# Access Compliance Report

## Public Rights-of-Way

### (Curb Ramps)

Intersection ID: 30311	Main Street: EUROSTAR_DR	Cross Street: ROCKET_LN	Location: S
ADA ID: EB95267A6D1C	Ramp Type: PerpDiag	Initial Pass/Fail: Fail	Overall Compliance: No
		Severity Score: 10

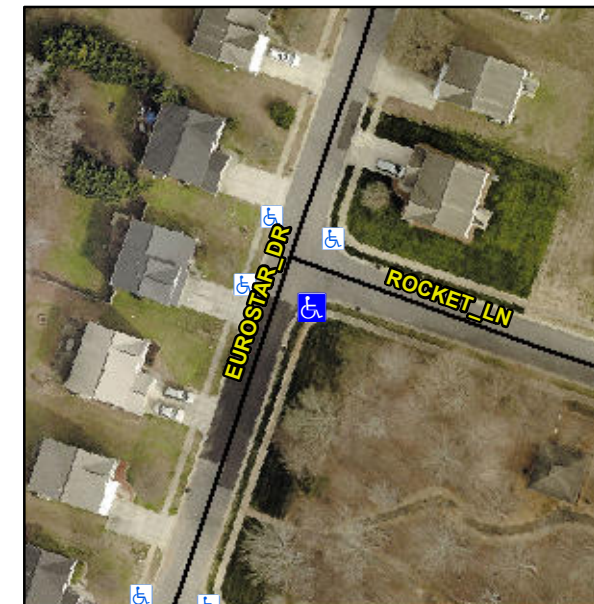
**Not Found, R304.5.1, R304.5.3**

Compliance	Description	Data	Compliance	Description	Data
N/A	Ramp Length (in)	46.0	Yes	Ramp Slope (%)	8.1
No	Ramp Width (in)	41.0	No	Ramp XSlope (%)	3.5
N/A	Flare Type LT	N/A	N/A	Flare Type RT	N/A
N/A	Flare Slope LT (%)	N/A	N/A	Flare Slope RT (%)	N/A
N/A	Flare Traversable LT?	N/A	N/A	Flare Traversable RT?	N/A
N/A	Landing Length (in)	N/A	N/A	DWS Provided?	N/A
N/A	Landing Width (in)	N/A	N/A	DWS Contrast?	N/A
N/A	Landing Slope (%)	N/A	N/A	DWS Length (in)	N/A
N/A	Landing X Slope (%)	N/A	N/A	DWS Full Width?	N/A
N/A	Landing Curb? (Y/N)	N/A	N/A	DWS Offset (in)	N/A
N/A	Shared Landing?	N/A			
N/A	Gutter Ponding?	N/A	N/A	Gutter Slope (%)	N/A
N/A	Gutter Lip Ht (in)	N/A	N/A	Gutter X Slope (%)	N/A
N/A	Painted X Walk1?	No	N/A	Painted X Walk2?	No
	X Walk 1 Direction	To NE		X Walk 2 Direction	To NW
N/A	X Walk 1 Width (in)	N/A	N/A	X Walk 2 Width (in)	N/A
	X Walk 1 Slope (%)	1.8		X Walk 2 Slope (%)	2.9
	X Walk 1 X Slope (%)	4.7		X Walk 2 X Slope (%)	0.5

**Remove & Replace Curb Ramp With Two New Directional Ramps or Equivalent.**
